May 21, 2020

**FROM:** Planning Staff, Building and Planning Department

**SUBJECT: PRELIMINARY SUBDIVISION PLAN – 255, Fairhill Road, Wynnewood, SD# 3855, Ward 5.**

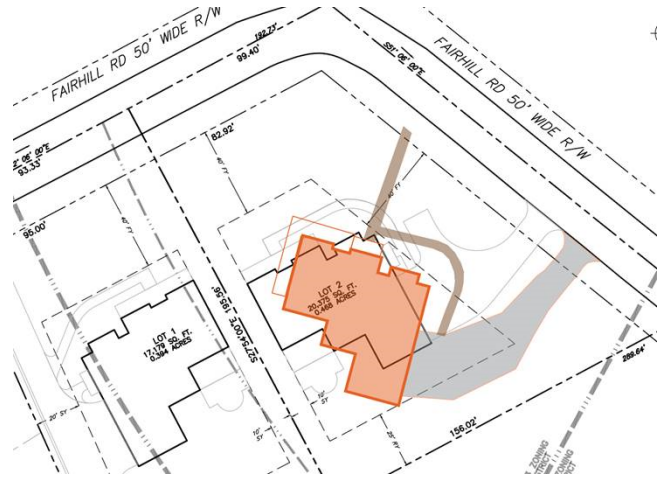
Following the submission of the application staff recommended that the applicant consider reorienting the home and driveway on Lot 2, as shown in the below graphic, so that the garage would not be front loaded. The applicant stated that the applicant does not desire to reorient the house and related improvements. Staff has recommended a condition that requires the applicant to investigate revising the plan so that the garage is side loading garage and consistent with existing neighborhood pattern or providing a street screen, such as a low wall or hedgerow along Fairhill Road to screen the view of the front loaded garage from the street.
